City of Santa Fe, New Mexico

memo

2026-012578-HDRB. 426 Delgado Ln., Downtown & Eastside Historic District, contributing, Gayla Bectol, agent for Paige Cochran and Kareem Abu-Zeid, owners, proposes to replace windows and construct 570 sq. ft. of additions to the main residence, construct an 800 sq. ft. garage addition to the guesthouse to a height of 12'-6", where the maximum allowable height is 13'-11". Remove a section of the contributing wall and install a 6'-0" high vehicle gate. An exception is requested to section 14-4.6(E)(4)(II) to remove historic material.

STAFF RECOMMENDATION:

Figure 3: East Yard wall: planter on left is approximate location of proposed opening

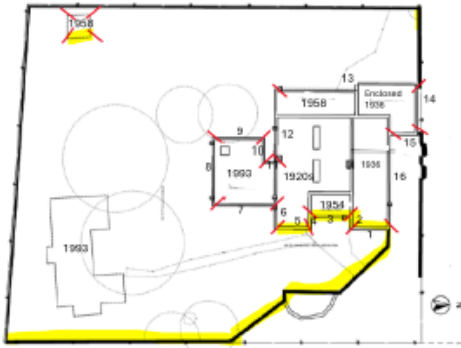
- 7) Create an opening in the contributing east yard wall in order to create a driveway access to the new garage structure. An exception is requested to section 14-4.6(E)(4)(II) to remove a section of the contributing wall.
- 8) Install a vehicle gate in the new opening of the east yard wall. The gate will be metal frame with wood.
- 9) Install a wall with pedestrian gate at the north end of the residence between the end of the east yardwall and the north yard wall. The pedestrian gate will mimic the existing gates in the east yard wall.

Staff finds that the exception criteria have been met and recommends approval of the exception to 14-4.6(E)(4)(II) to remove a section of a contributing yard wall. Otherwise, staff recommends approval of the other elements of the application as they comply with 14-5.2(D) General Design Standards for all Historic Districts, and 14-4.6(G)(2) Downtown and Eastside Historic District Design Standards.

Figure 4: Proposed Site Plan

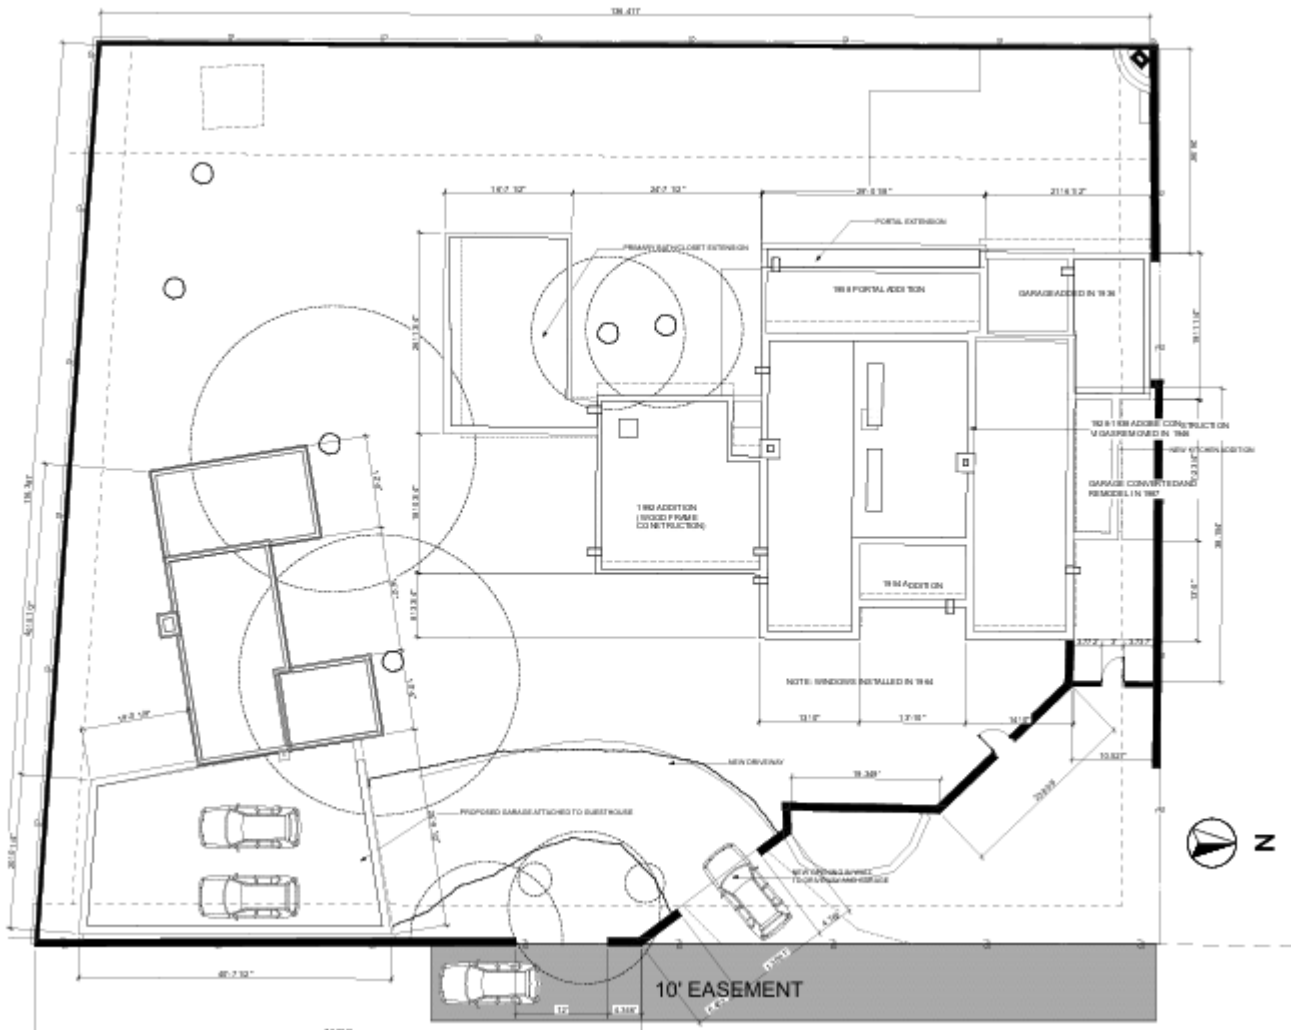
Exception to section 14-4.6(E)(4)(II): The applicant requests an exception to create an opening and install a vehicle gate in the contributing east yard wall.

Applicant Response: The new opening is the minimum change necessary in order to access the new garage easily from the extension of Delgado Lane. Similar to most of the openings along the lane it will give access to the house for the automobile and provide parking off the street.

Applicant Response: The owners would like to make the garage access as convenient as possible. If the opening is not provided in this location the applicant will have to continue to use the existing opening off of the easement/extension and make a hard at least three point turn into the garage. With two adults and a young child getting in and out of the driveway at right angles to the garage that will eventually leave the garage unused most of the time. Either option doesn't injure the public welfare.

Applicant Response: In order to stay in this house, the owners would like to make the garage access as convenient as possible. The garage addition is allowed to the guesthouse and the most logical place for the garage is next to the yard wall leaving as much of the historic open space around the house as possible.

Staff Response: Staff finds that this criterion is met. This streetscape contains off street parking for most residences. This residence is an exception with no vehicle access to the property. The current parking space for the property is due to a parking easement with the western neighbor. All other parking is on-street parking. By providing a garage and off-street parking, the property will be in keeping with the district and current parking requirements.

Staff Response: Staff finds that this criterion is met. The hardship is that there is an existing parking agreement/easement with the neighbor. The lot is not accessible with a vehicle which is a standard piece of equipment in modern times. Creating a way to park vehicles on the lot will make the property more livable. So, creating a means to access that parking is required. The current access in the yard wall would create a need to make a sharp ninety-degree turn to park the vehicle in the garage. This opening is not wide enough to allow this type of turn into the garage.

Staff Response: Staff finds that this criterion is met. The existing opening in the wall is directly in front of the planned garage which will cause hardship for entering and using the garage in the planned location. The planned location of the garage is meant to keep the property with an estate feeling, by keeping more open space. Relocating the garage would not be feasible without massive loss of open space and significant trees, plus a redesign of the house which is taking those trees into consideration. The location of the opening minimizes the impact on the yard wall by fitting into a turn in the wall. The design as it is, is the least damaging to the property as a whole and will retain the continued use of the property.
